Response to Submissions Preferred Project Report

60-78 Regent Street, Redfern

Student Accommodation

Submitted to NSW Department of Planning & Environment
On Behalf of Iglu Pty Ltd

Figure 1 – Extract from amended ground floor plans
Source: Bates Smart

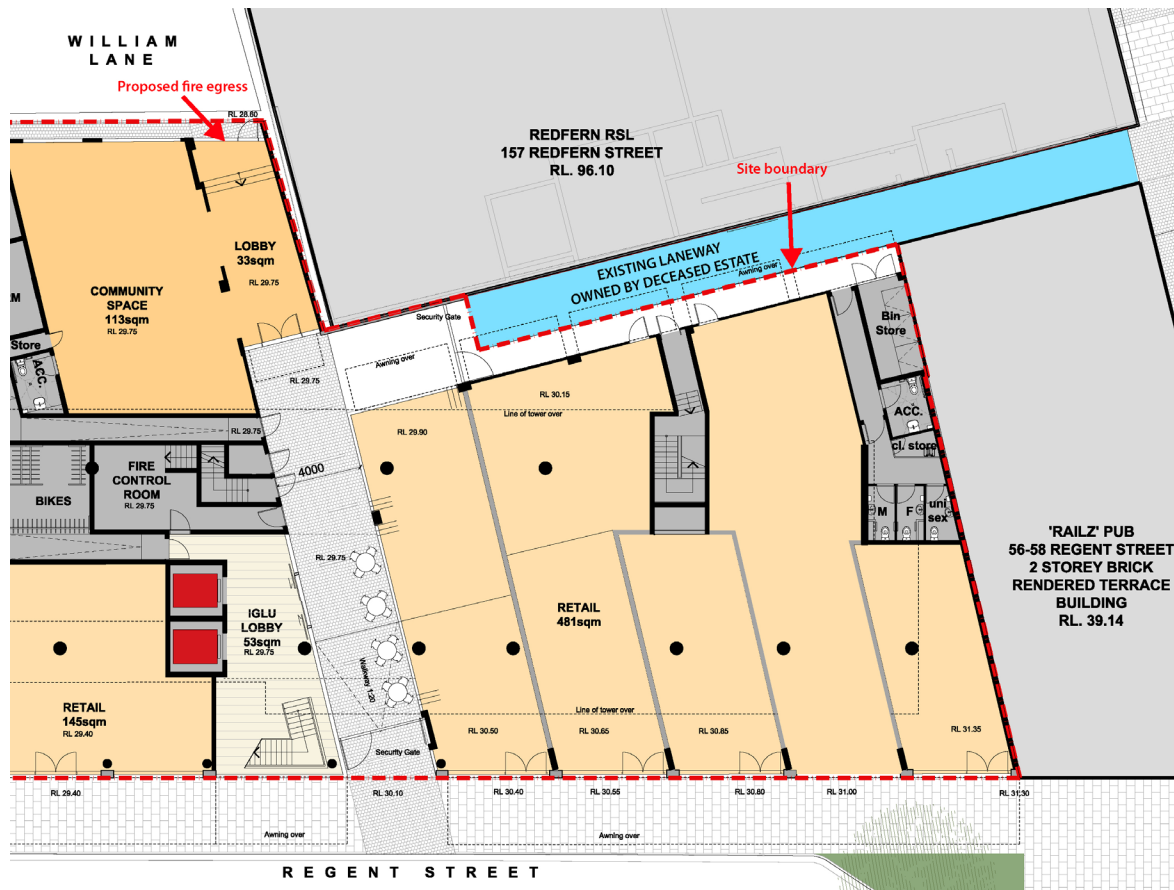
The ownership of the small laneway off Redfern Street was identified as a potential issue in the project conception phases for Iglu Redfern. It had come to the project team's attention in early planning phases that this small parcel of land is not in public ownership, but is in fact owned by a deceased estate from the mid-1850s. The ownership of this land was not identified in the previous assessment of projects adjoining this laneway, such as for the 157 Redfern St (Redfern RSL) site (MP 09_0039), which includes a number of fire exits discharging directly to this laneway. The laneway is also used for storage and waste disposal by a number of retail tenancies adjoining this land, and a gate has been installed across the southern half of this laneway. Iglu has not been able to obtain land owner's consent from the deceased estate for the use of this laneway, and as such it is proposed to remove this parcel of land from the current SSDA. As a result, pedestrian access will no longer be provided via the Site through to Redfern Street. All proposed retail tenancies will address Regent Street, with a corridor of land provided within the Site for rear-servicing and emergency egress from these tenancies. This site boundary will be secured with a fixed fence.

In addition to the above, the Redfern Local Area Command of the NSW Police Force has requested that the internal laneway should not provide public access through to William Lane for safety reasons. The potential conflict between this pedestrian access and vehicle movements associated with the 7-9 Gibbons Street development was also raised as a matter of concern in public submissions. Given that William Lane is not activated and does not have pedestrian facilities, Iglu is willing to remove this linkage.

As a result of the above, Bates Smart have made a number of design changes to the proposed ground level within the Site. Only one pedestrian entrance will now be provided to the Site (from Regent Street), and this will be for the purpose of providing access to the dance studio, rear-servicing of the ground-level tenancies and fire access. A new waiting area/lobby will be created for the proposed dance studio to fill this corner. Fire egress will continue to be provided to William Lane to comply with the relevant fire and building standards.

Amended Architectural Drawings detailing the proposed changes are provided at **Attachment A**, an extract of which is provided at **Figure 1** below.

Figure 2 – Proposed detail of angled window hoods

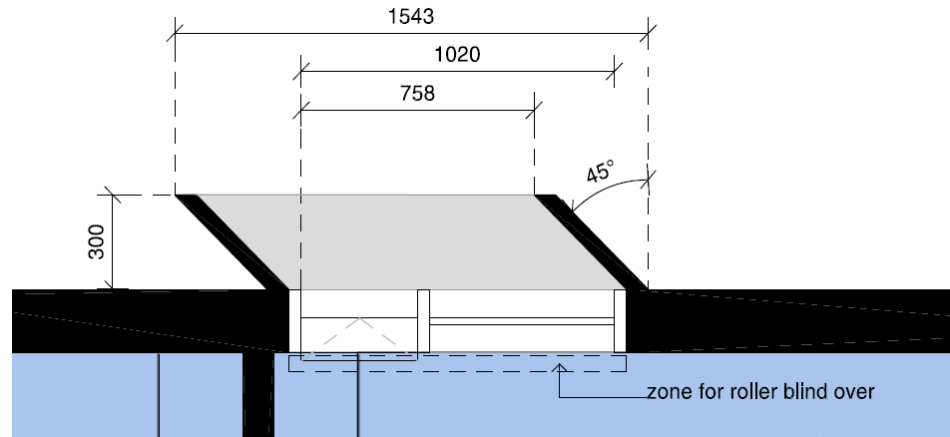
A number of public submissions raised concern regarding the proximity of west-facing bedrooms within the proposed development to dwellings in the adjoining mixed use development on the Redfern RSL site (157 Redfern Street). To minimise the direct visual interface between existing dwellings and proposed bedrooms, it is proposed to angle the window hoods for west-facing bedrooms by 45° to face away from the closest dwellings in the Redfern RSL site. The effectiveness of this design measure is discussed in **Section 4.2** of this report and in the addendum design statement provided at **Attachment D**. **Figures 2** and **3** below provide additional detail regarding the design and appearance of the modified window hoods.

In addition, operable window blinds will be installed to all west-facing bedrooms that allow students to completely block the window from ceiling to floor level.

- angling the external window hoods for west-facing bedrooms by 45° away from the closest dwellings; and
- providing operable blinds within west-facing apartments to enable students to further reduce direct lines of sight.

Figure 8 – View impacts to dwellings within 7-9 Gibbons Street building
 Source: Bates Smart

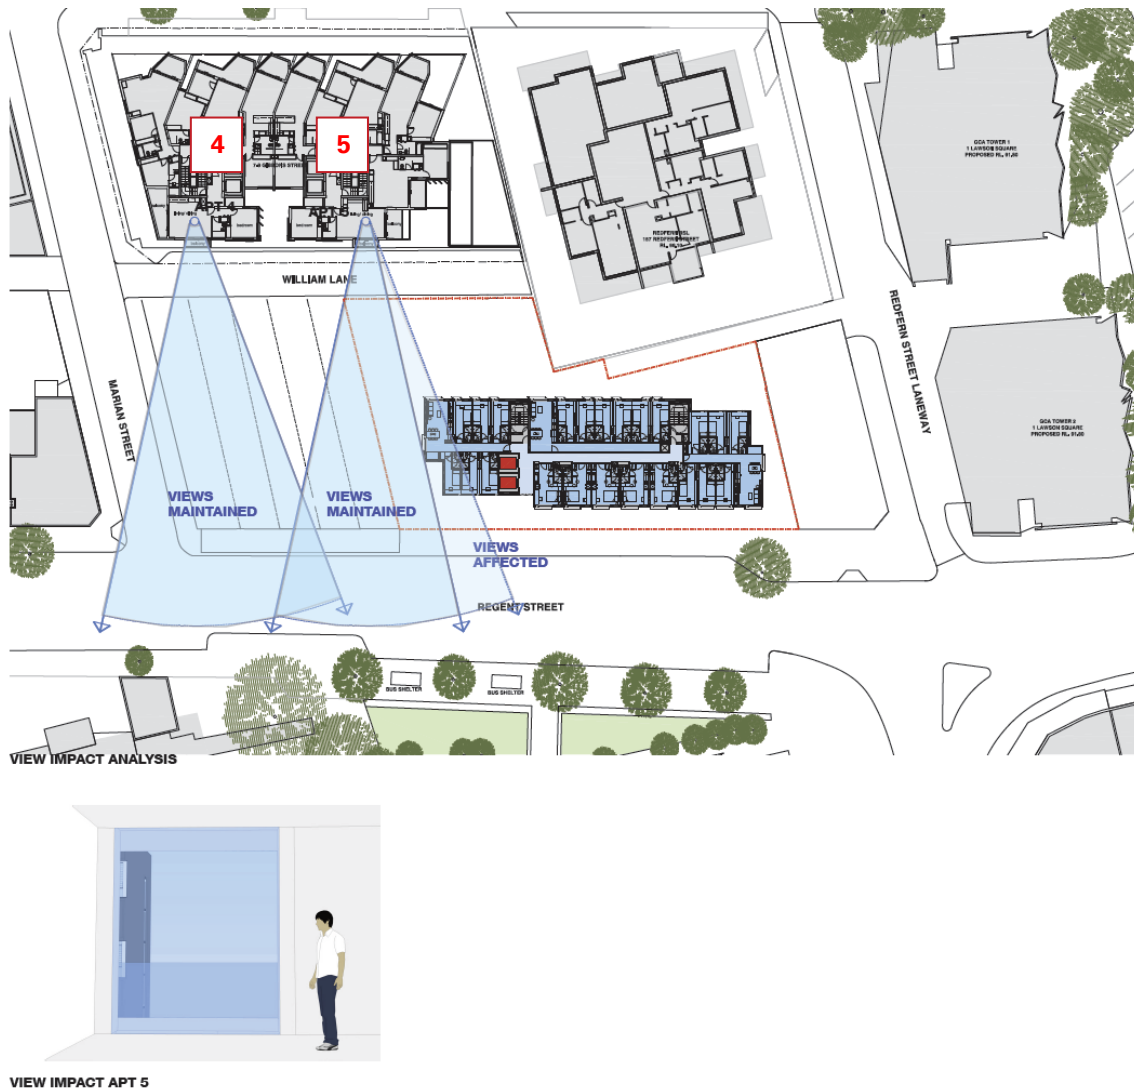
55 submissions from the public objected to the impact of the proposed development of existing views gained from existing east-facing dwellings in the 7-9 Gibbons Street and 157 Redfern Street (Redfern RSL) buildings. The height of the proposed building was also raised in 59 submissions. It is noted that many of the submissions raised both issues together, so that the number of submissions raising either of these issues is much lower than the combined total. The issue of view loss was not raised in submissions from Council or other government agencies.

In the 7-9 Gibbons St building, view from the living area of Apartment 4 will be unaffected by the proposed building, whilst there will be some minor loss of views to Apartment 5.

Figure 11 – Illustration of the effect of angled hoods in reducing western views
Source: Bates Smart

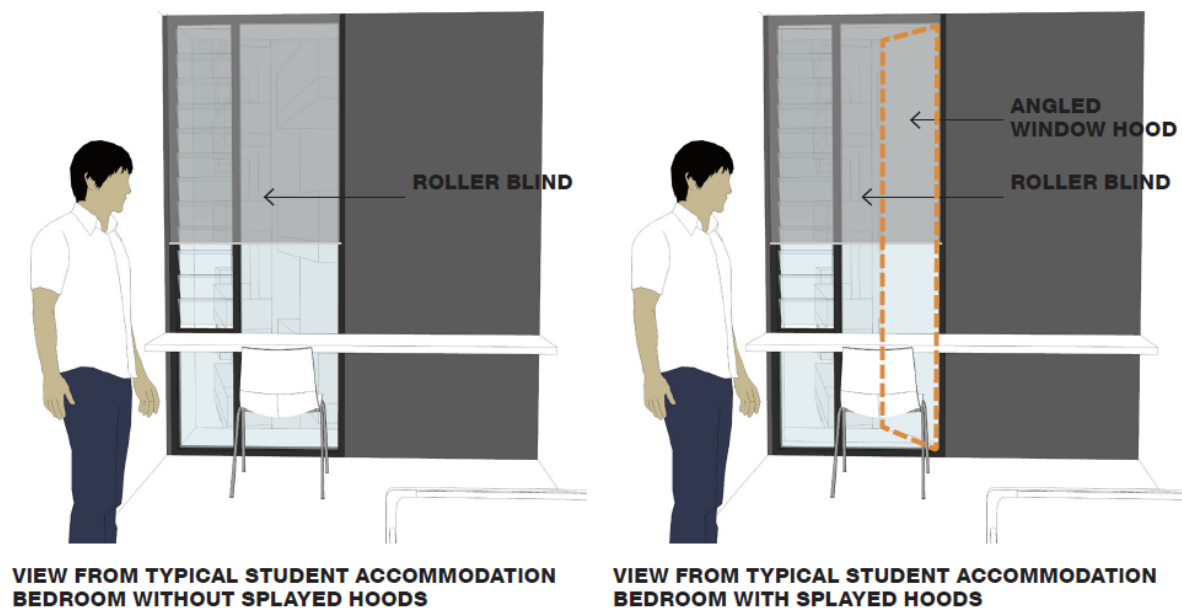
90 submissions raised concern regarding the impact of the proposed development on the internal visual privacy of dwellings adjoining the Site, particularly within the 157 Redfern St and 7-9 Gibbons St buildings. These submissions raised concern regarding the number and orientation of windows for west-facing bedrooms within the proposed development.

The effect of the angling of the external window hoods is to further reduce the area of the direct western view from within the room by approximately 25% as illustrated in **Figure 11** below. Furthermore, the angling of the hoods will naturally encourage direct views away from the closest dwellings in the 157 Redfern Street building as illustrated in **Figure 12**. This design solution is considered to appropriately balance the need to improve the privacy outcome, continue to allow natural light to enter bedrooms and ensure that required ongoing maintenance and cleaning is feasible.

Figure 13 – Building separation measurements
Source: Bates Smart

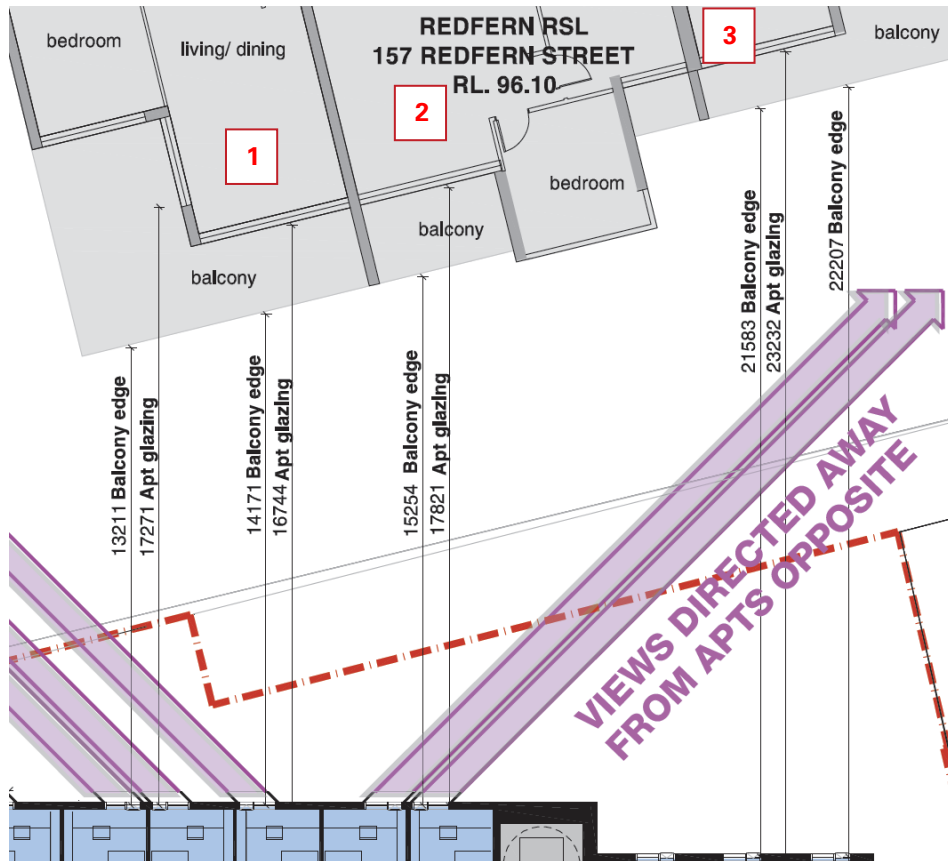
A number of public submissions raised concern that the physical separation between the existing apartments in the 157 Redfern St and 7-9 Gibbons St buildings. In particular, a number of submissions raised concerns that the proposed development does not comply with the upper-level building separation controls for residential flat buildings under the RFDC.

Figure 13 below illustrates the proximity of proposed bedrooms to existing dwellings in the 157 Redfern Street building, which demonstrates that the following minimum separation distances provided throughout the height of the building:

- Apartment 1:
 - Minimum 13.21m to balcony edge
 - Minimum 16.74m to living area
- Apartment 2:

- Minimum 15.25m to balcony
- Minimum 17.82m to living area
- Apartment 3:
 - Minimum 21.58m to balcony
 - Minimum 23.23m to living area

The proposed building separation complies with the 'rules of thumb' for lower levels and the separation to living areas is close to the 'rules of thumb' for middle levels. Under the RFDC, if the separation distances are achieved there is no need for additional privacy measures. Given the extensive privacy measures proposed to the western façade as discussed above, and given that the RFDC does not technically apply to the proposed development, it is considered appropriate to adopt a merit-based consideration of the reduced building separation for the upper levels. This is particularly the case given the built form context and constraints on providing an increased setback to the western boundary of the Site.

Figure 14 – Additional overshadowing cast at 9am on 21 June (winter solstice)
 Source: Bates Smart

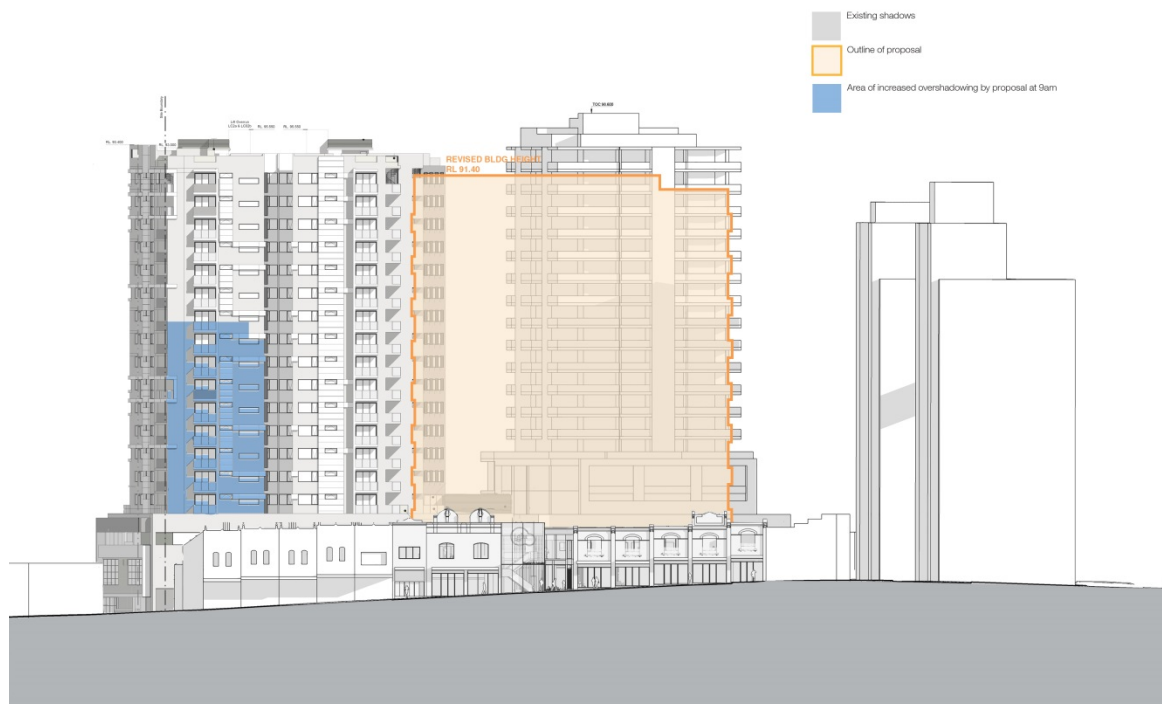
Overshadowing was the most prominent issue raised in public submissions, being raised in 104 of the 121 submissions received, which predominately related to overshadowing of dwellings in the adjacent residential flat buildings.

The EIS was accompanied by shadow diagrams illustrating the extent of shadows cast during the winter solstice in both 2D plan form, 3D 'view from sun' format and in elevation profile. As illustrated in the extract from these diagrams in **Figure 13** below, the only additional overshadowing of these buildings would occur from 9am at the winter solstice, and this shadow will have moved away from these dwellings by 10am.

The loss of less than one hour of sunlight for a small number of dwellings in the 7-9 Gibbons Street building between 9am and 3pm is considered to be acceptable given that:
